Change GF02:

Rezoning from Rural to General Residential 1 – 201, 207 and 211 Gladstone Road South

Adding housing capacity in Dunedin (2GP Variation 2)

Wet Area showing where the grass is Green.

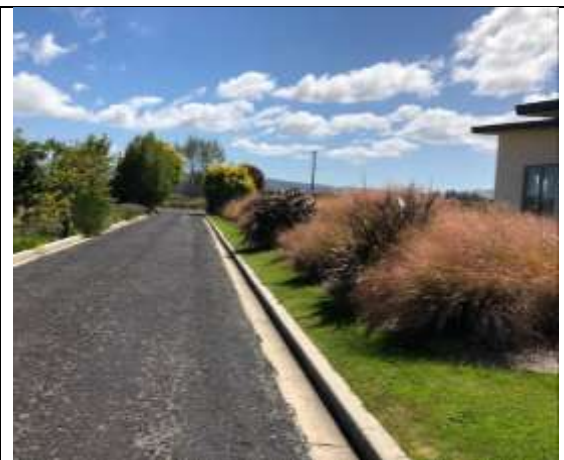
The gap in the hedge shows where the wet area exits the section.

During times of flooding or extensive rain water tracks through from 201 to 207 creating a ponding area in the natural waterway shown in adjacent photos.
